**HISTORIC PRESERVATION REVIEW BOARD  
STAFF REPORT AND RECOMMENDATION**

Landmark/District: **Foggy Bottom Historic District** (x) Agenda  
Address: **2431 I Street NW**

Meeting Date: **December 4, 2014** (x) Addition  
Case Number: **14-625**

Staff Reviewer: **Tim Dennée** (x) Concept

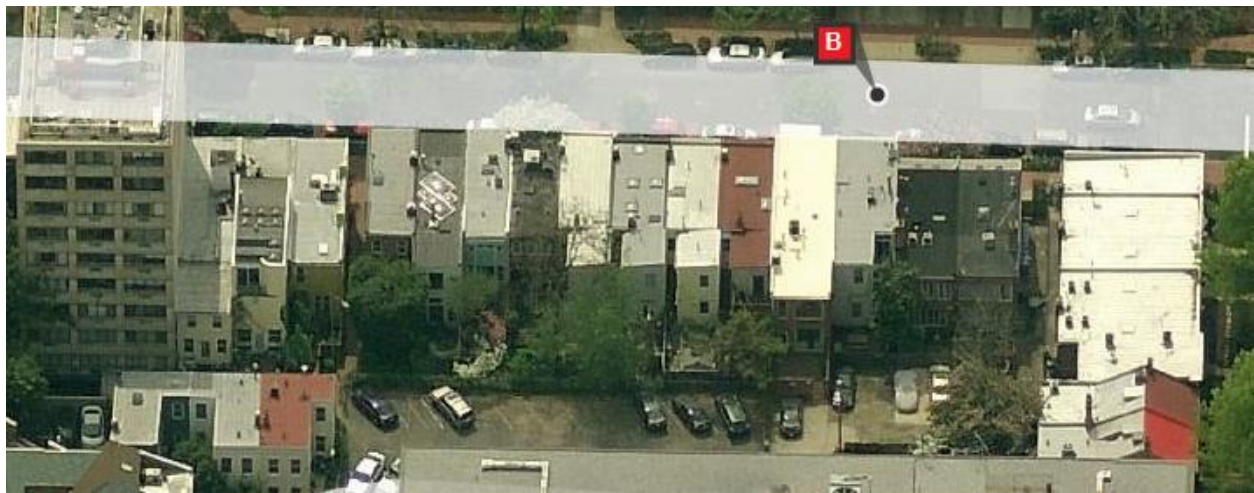
For that reason, the Board has applied another general principle, that in order to be set back sufficiently, a roof addition should be entirely behind the main block.<sup>3</sup> In the present instance, the proposed addition would stand not only on the little rear ell, but would come forward a dozen feet onto the main block. There, because of its height, it would be seen from the street, if only over the gable-roofed houses to the west.

*The HPO recommends that the Board find the concept to add a partial third story to be incompatible with the character of the historic district but support the idea of an addition similar to that proposed, but at the height of two stories, with the conditions that its cladding be a true stucco and that the façade's replacement windows be appropriate two-over-twos.*
